**CITY OF KELOWNA**  
**MEMORANDUM**

**Subject:**

**APPLICATION NO.** DP06-0007/  
DVP06-0008

**AT:** 1425 Glenmore Road

4.2 Site Location Map  
Subject Property: 1425 Glenmore Road N

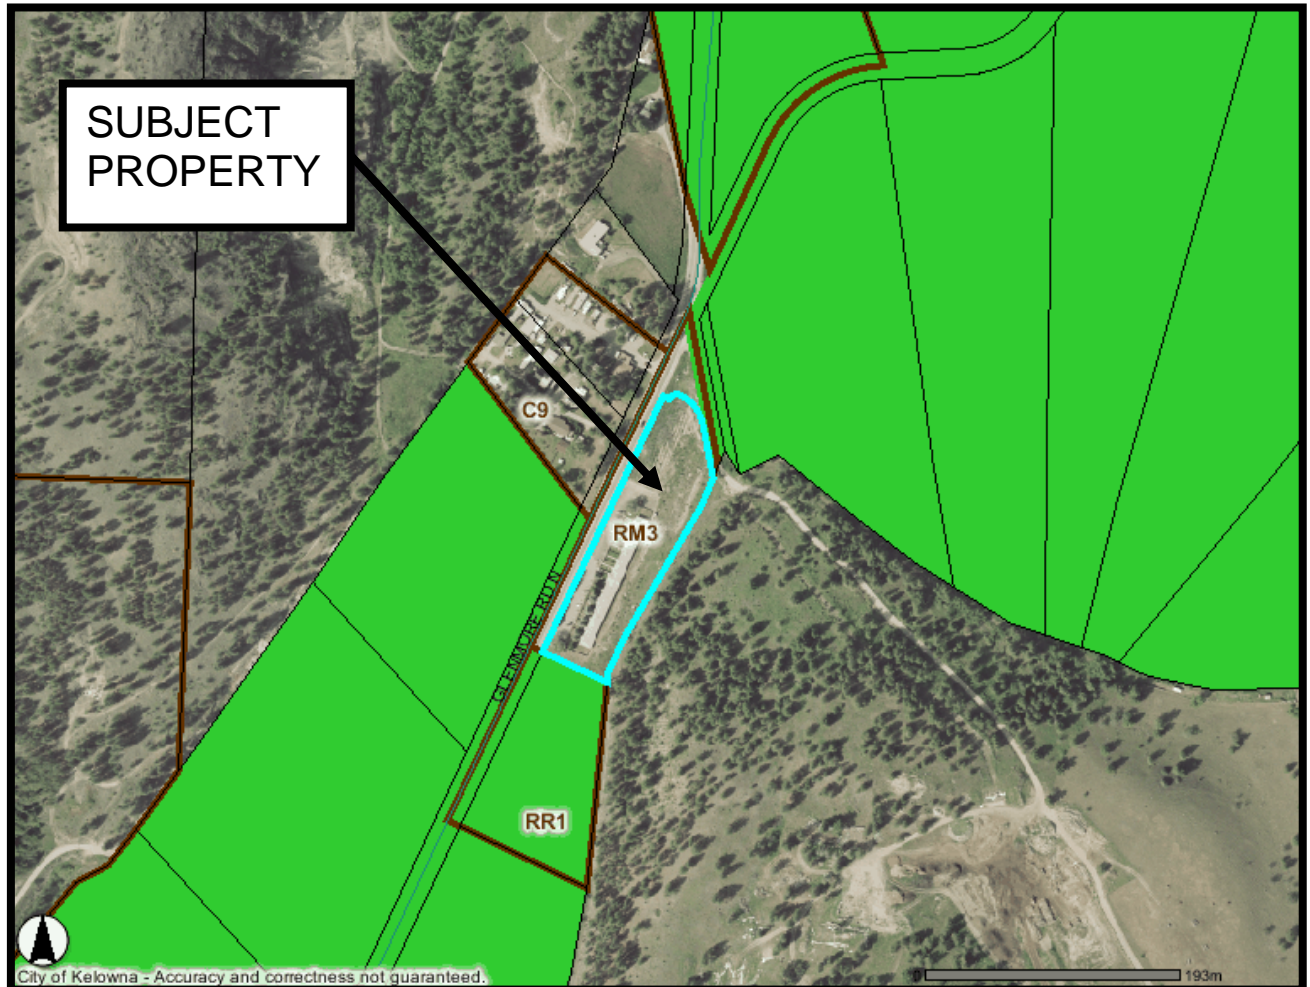
The subject property is located on the east side of Glenmore Road between Tutt Road and Galiano Road.

North - A1 – Agriculture 1  
 East - A1 – Agriculture 1 – Vacant Parcel – Non ALR  
 South - RR1 – Rural Residential 1 (ALR)  
 West - C9 – Tourist Commercial
